Re: North Campus Facilities

Subj: Change Proposal No. 233901-0011

Williamson County – North Campus Facility

ASI #08 – 4/10/2017

2 SECTION - STAIR 1 - ELEVATOR
1/4" = 1'-0"

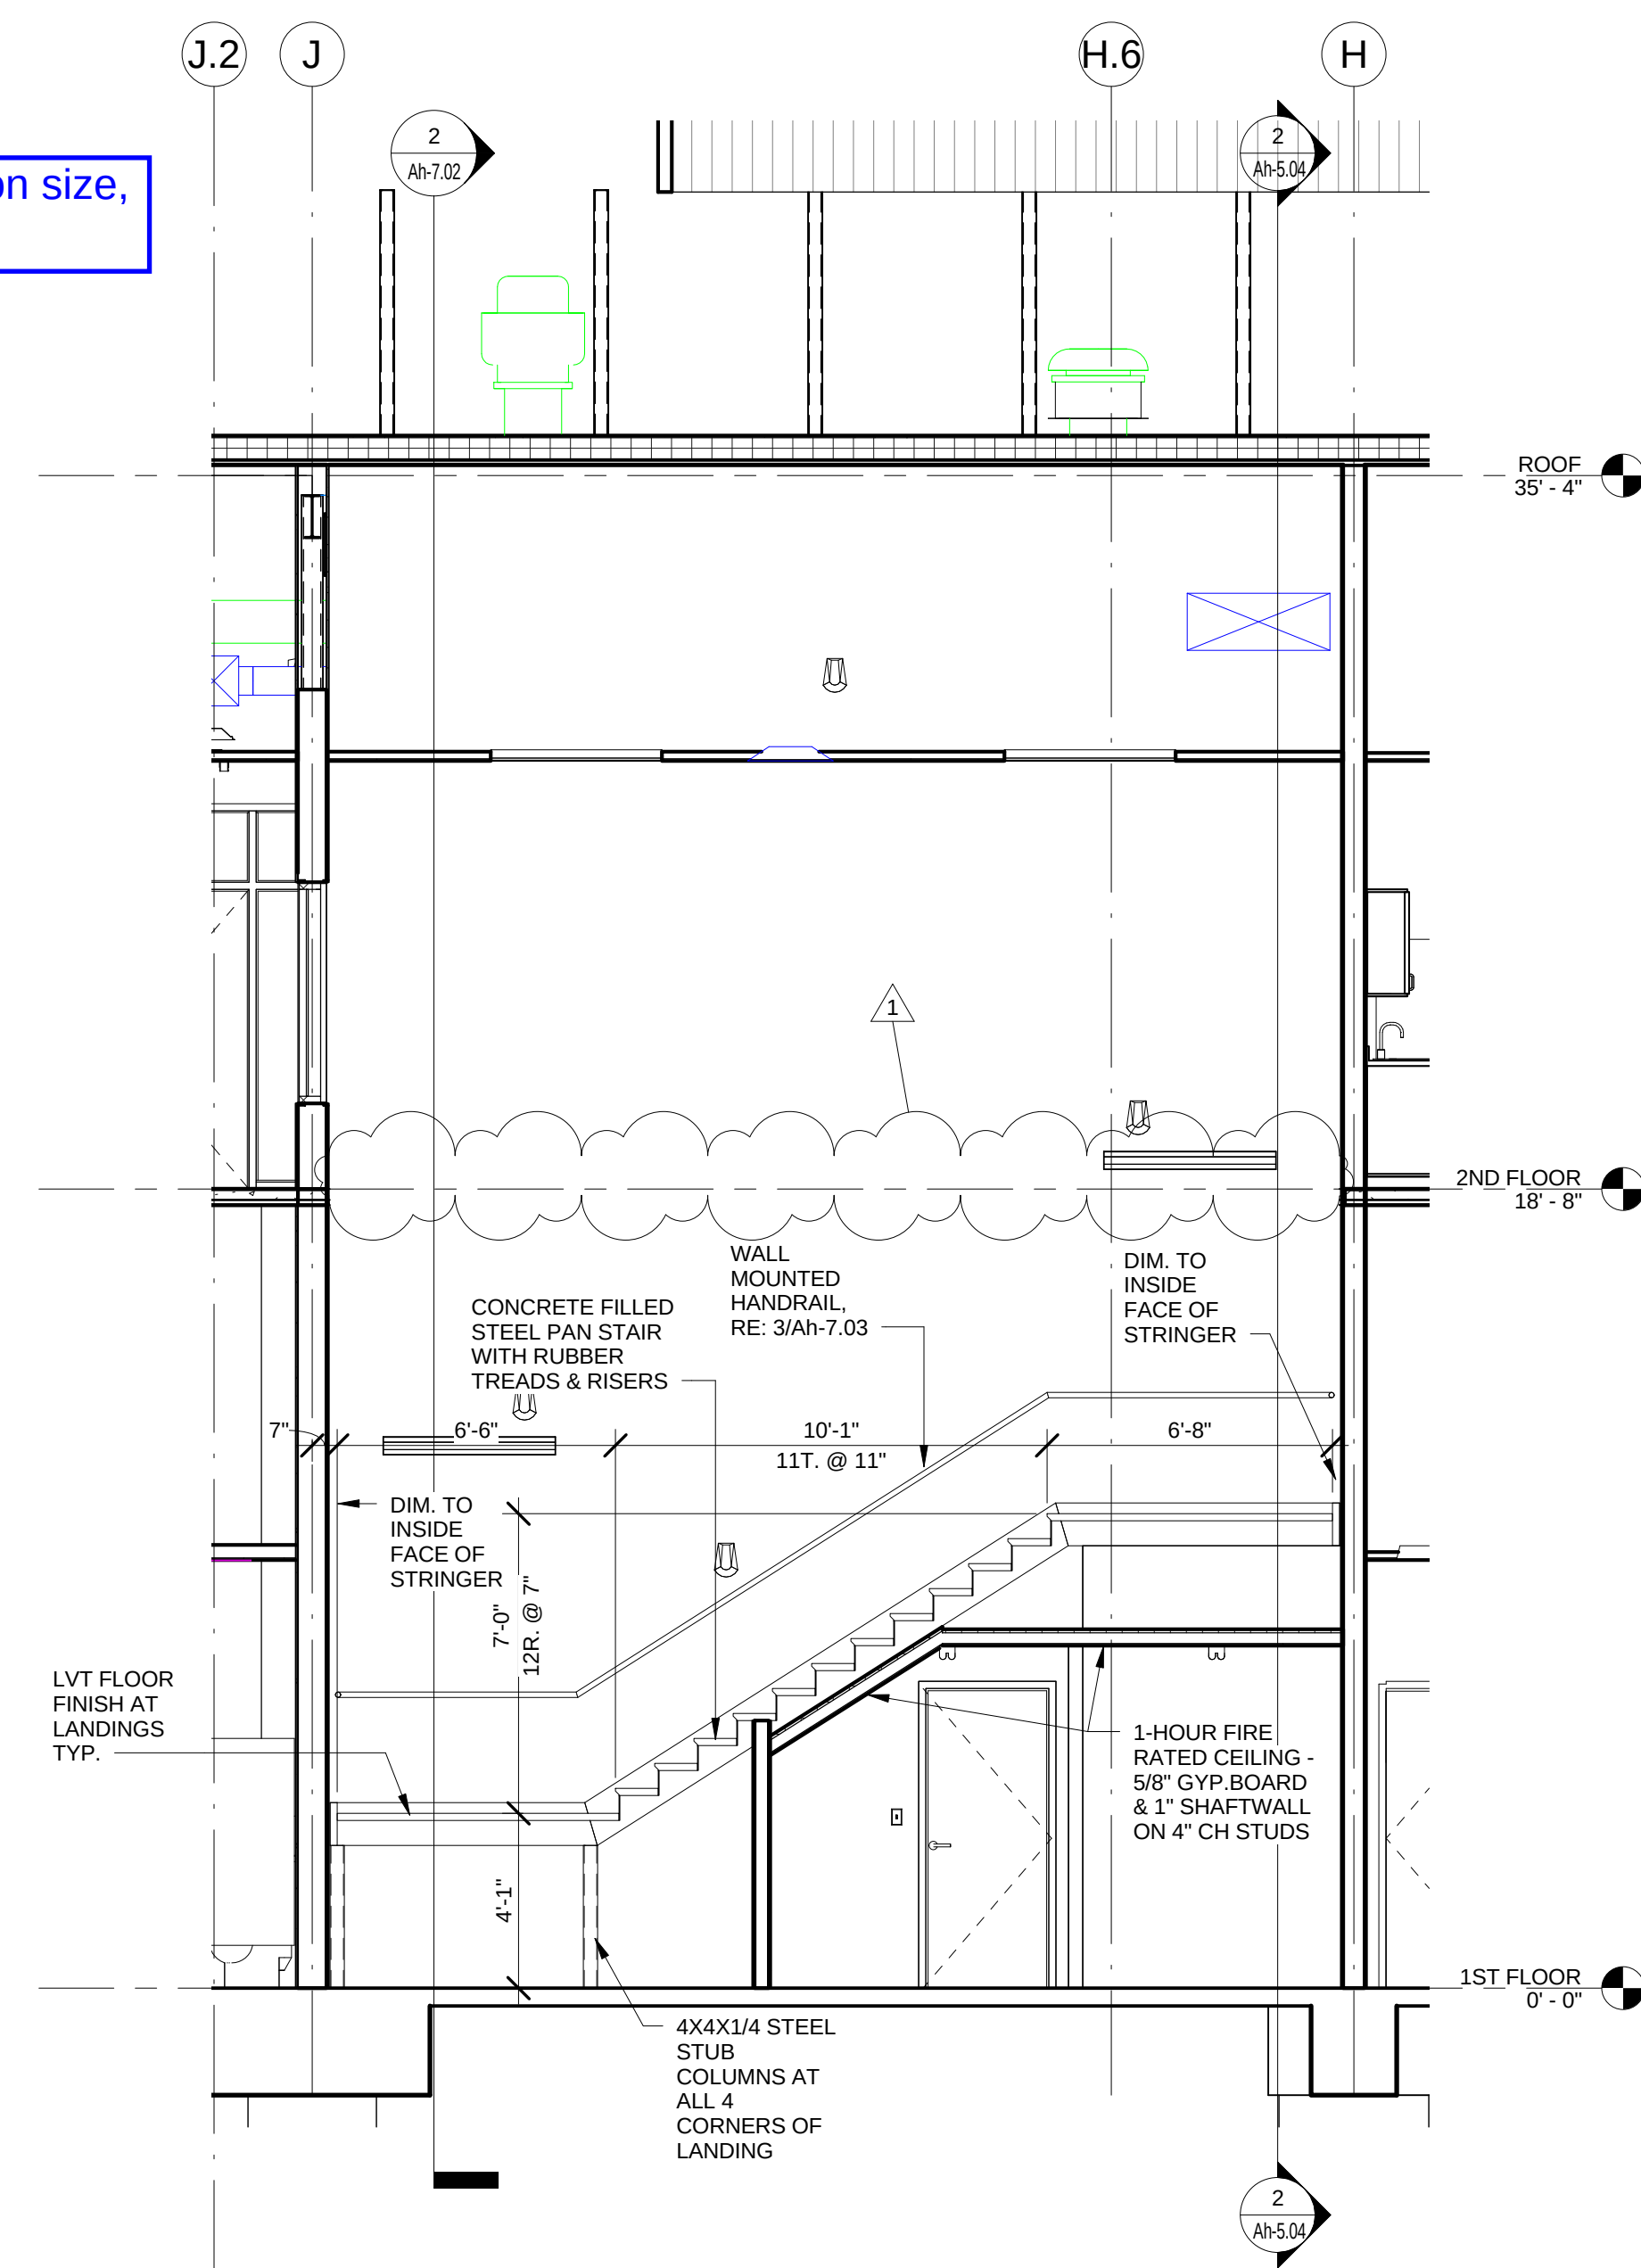
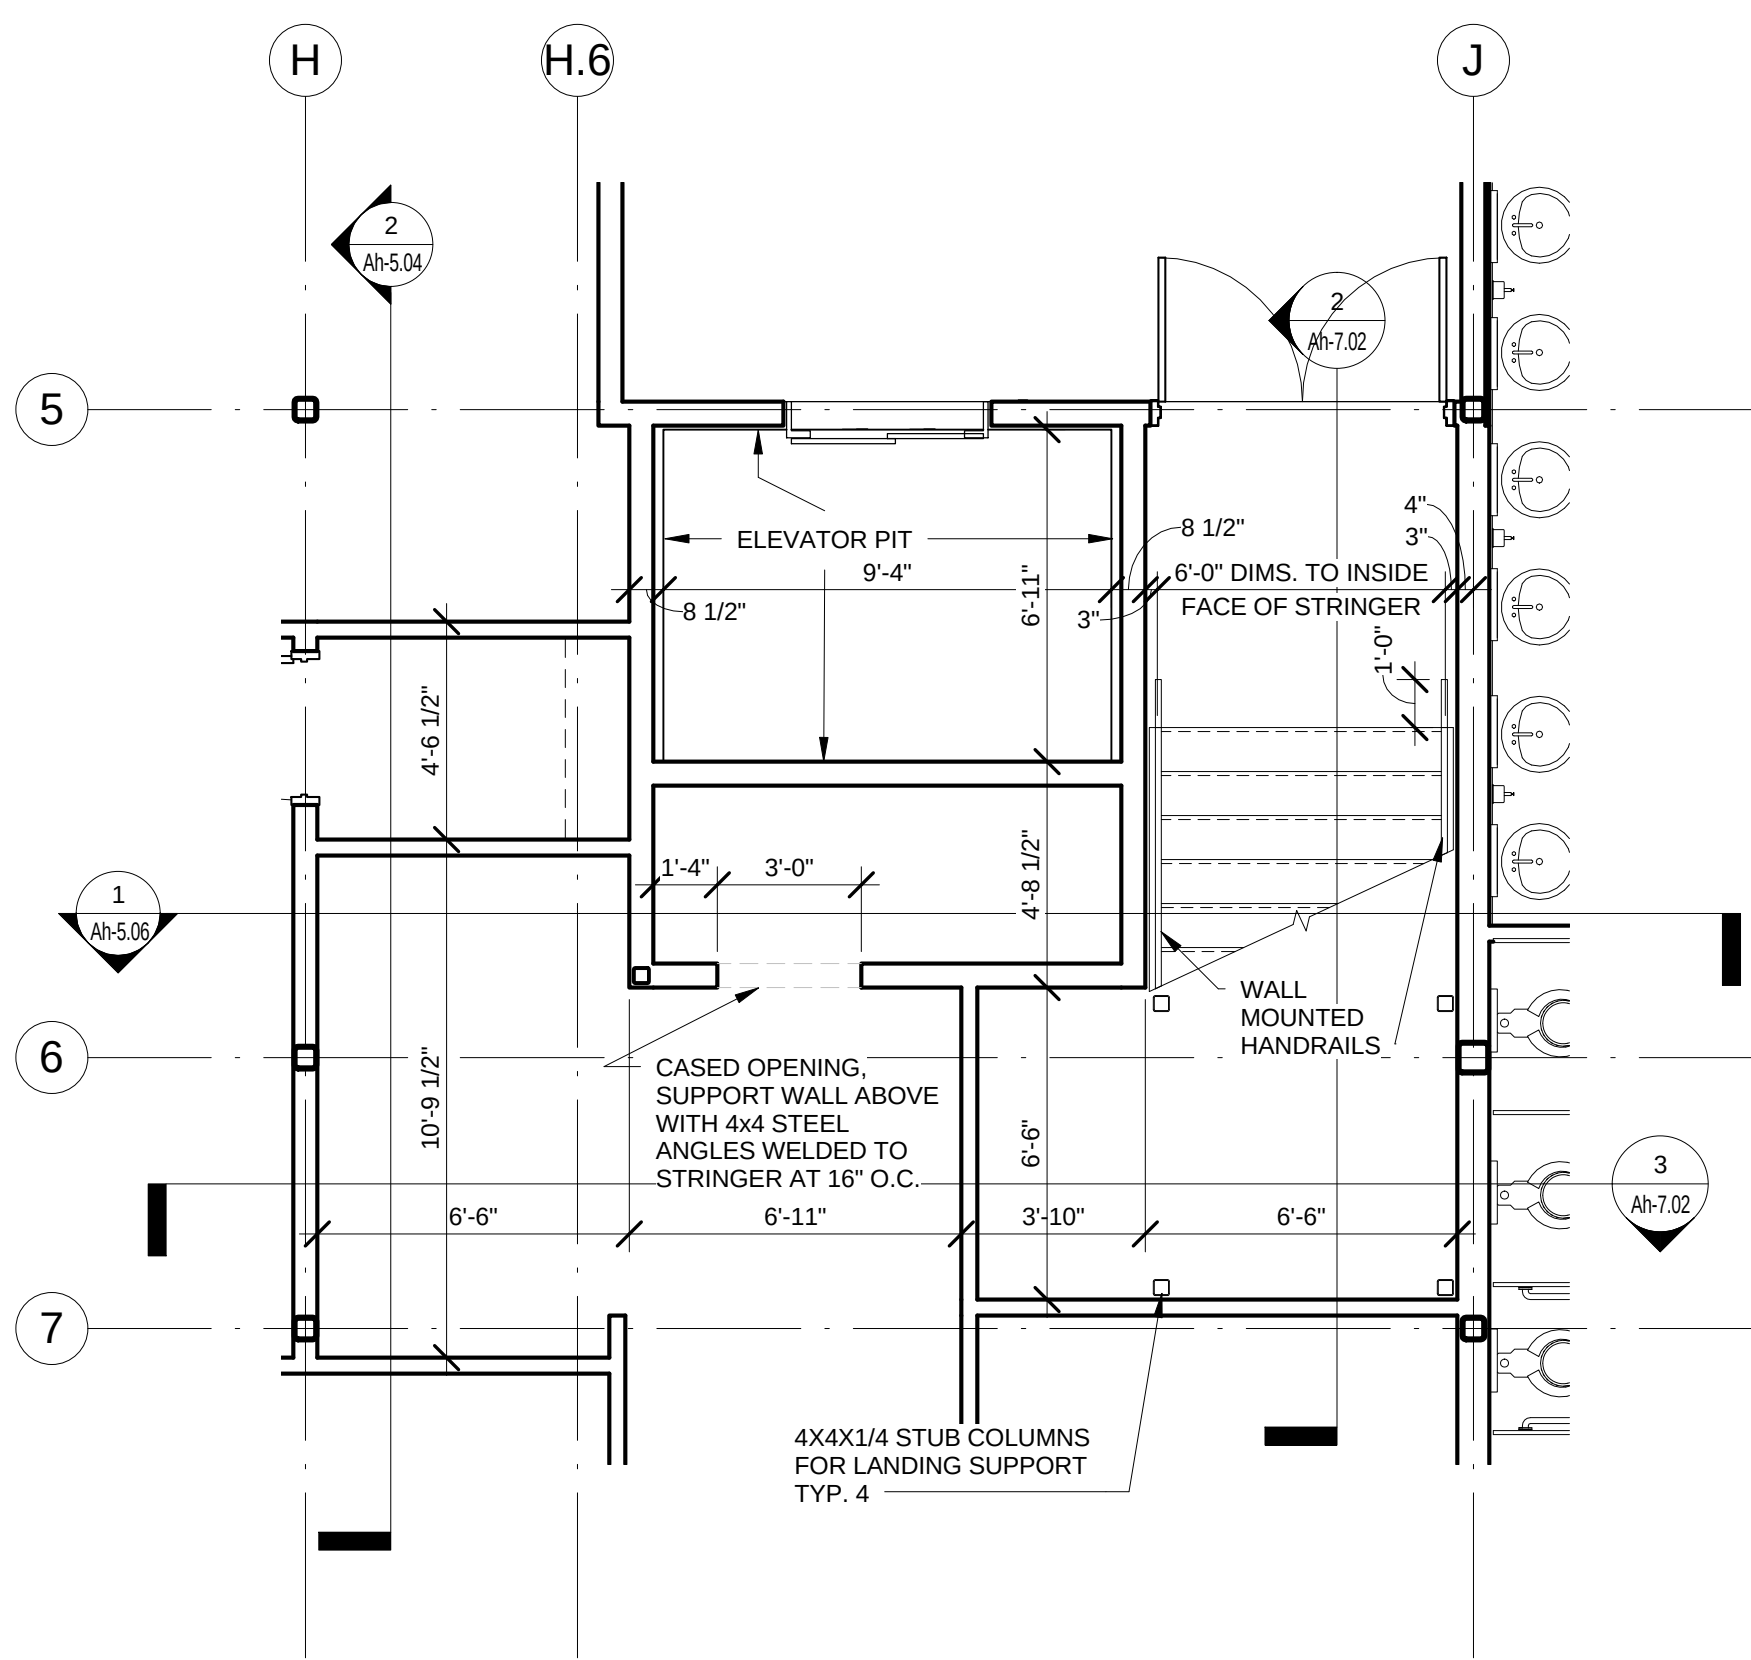
Please provide the hoist beam section size, location and connection details, as indicated in the attached sheet Ah-7.02.

Refer to attached details for structural steel posts and tube framing to support the hoist beam and to support the elevator guide rails as required by the elevator manufacturer.
